## **URGENT - Field Safety Notice**

### **Medical Device Correction**

### **Ingenuity CT, IQon Spectral CT, iCT, Brilliance 64 CT, Ingenuity TF, Vereos Step and Shoot Incorrect Image Phase Labeling**

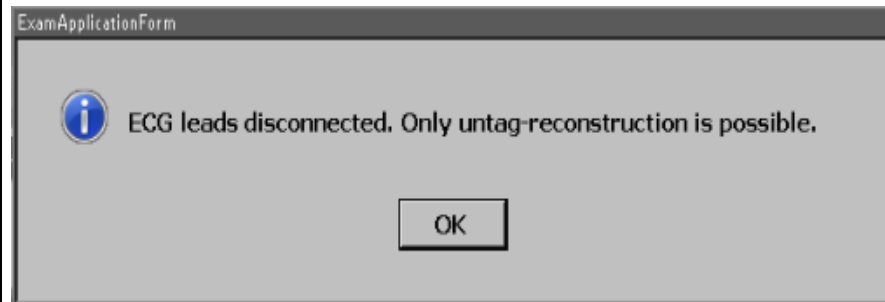
- This can occur with version 4.x software

- Should this occur, the user will receive the following console message:

- Images will be incorrectly labeled as if phase tolerance has been applied, however, the images will be reconstructed without phase tolerance.
- How to avoid: Ensure that the leads are securely attached to the patient prior to starting the acquisition and the length of table travel allows the leads to remain securely attached through acquisition completion. In the event of an application crash, there is no way to avoid the issue.
- When this issue occurs, images may still be used but are not labeled with the correct ECG phase. If images with phase tolerance are needed, a rescan may be required.

4.x Graphical User Interface example

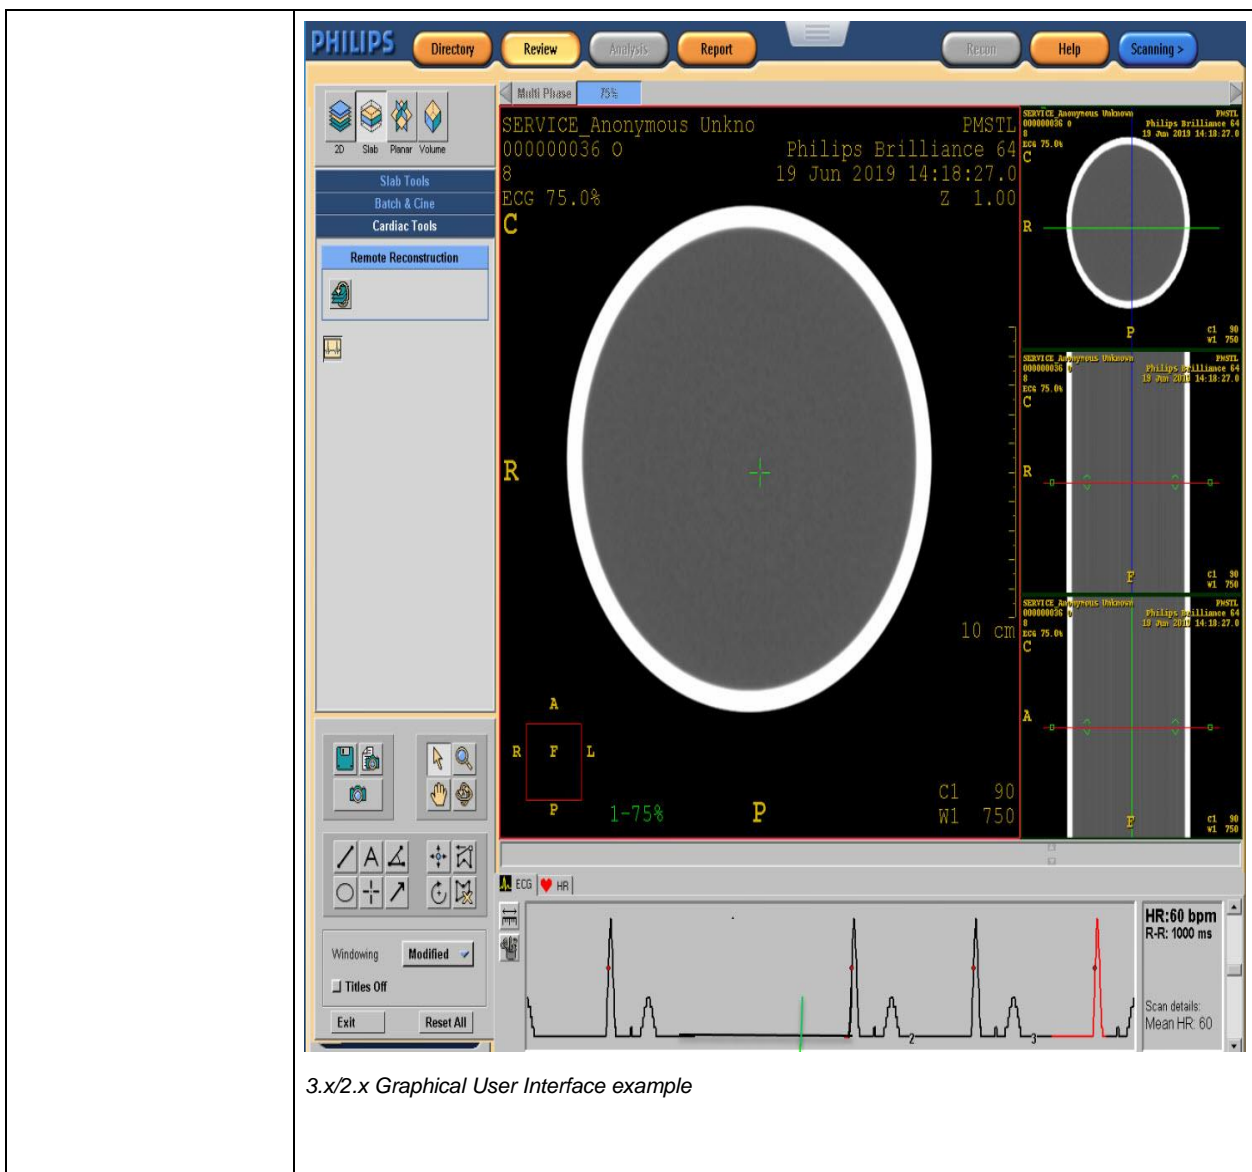
3. In some instances, when a patient exhibits an arrhythmia or varying heart rate during a Step and Shoot acquisition, images from the acquisition following the heart rate variation, may be labeled in the incorrect phase.

- This is by system design. In cases where the heart rate changes or an arrhythmia occurs, the white arrow/green line in the ECG display is not aligned on top of the acquisition.
